Access Compliance Report Public Rights-of-Way (Curb Ramps)

Main Street: DANA_POINT_HARBOR_DR Cross Street: COVE_RD Location: NW

ADA ID: RPRK220208180837 Ramp Type: Type 1 - Perpendicular Initial Pass/Fail: Fail Overall Compliance: No Severity Score: 15

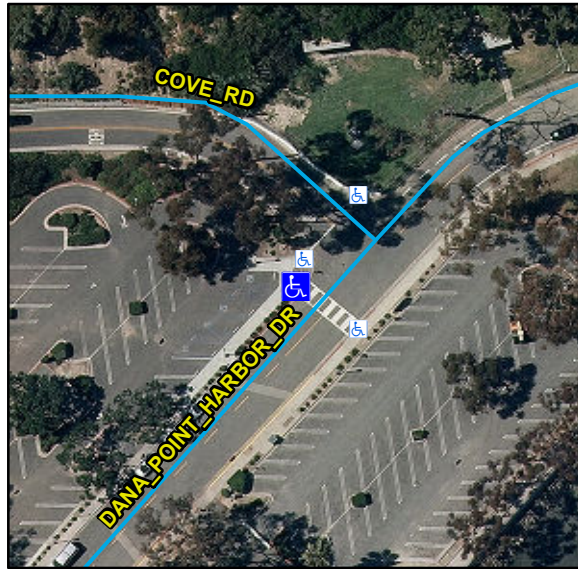
Compliance	Description	Data	Compliance	Description	Data
N/A	Ramp Length (in)	57	N/A	Flare Type LT	
Yes	Ramp Width (in)	48			N/A
Yes	Ramp Run Slope (%)	2.2	N/A	Flare Slope LT (%)	N/A
No	Ramp Cross Slope (%)	5.6	N/A	Flare Traversable LT	N/A
N/A	Landing Present	N/A	N/A	Flare Type RT	
N/A	Landing Length (in)	N/A			N/A
N/A	Landing Width (in)	N/A	N/A	Flare Slope RT (%)	N/A
N/A	Landing Run Slope (%)	N/A	N/A	Flare Traversable RT	N/A
N/A	Landing Cross Slope (%)	N/A	N/A	DWS Provided	N/A
N/A	Landing Movement Obstructed?	N/A	N/A	DWS Contrast	N/A
	Landing Movement Type	N/A	N/A	DWS Length (in)	N/A
N/A	Landing Shared	N/A	N/A	DWS Full Width	N/A
N/A	Clear Space	N/A	N/A	DWS Offset Left (in)	N/A
N/A	Clear Space To Crosswalk (in)	N/A	N/A	DWS Offset Right (in)	N/A
N/A	Marked Crosswalk 1	No	N/A	Marked Crosswalk 2	N/A
	Crossing 1 Direction	S		Crossing 2 Direction	N/A
	Marked Crosswalk 1 Width (in)	N/A		Marked Crosswalk 2 Width (in)	N/A

Remove & Replace Entire Ramp.
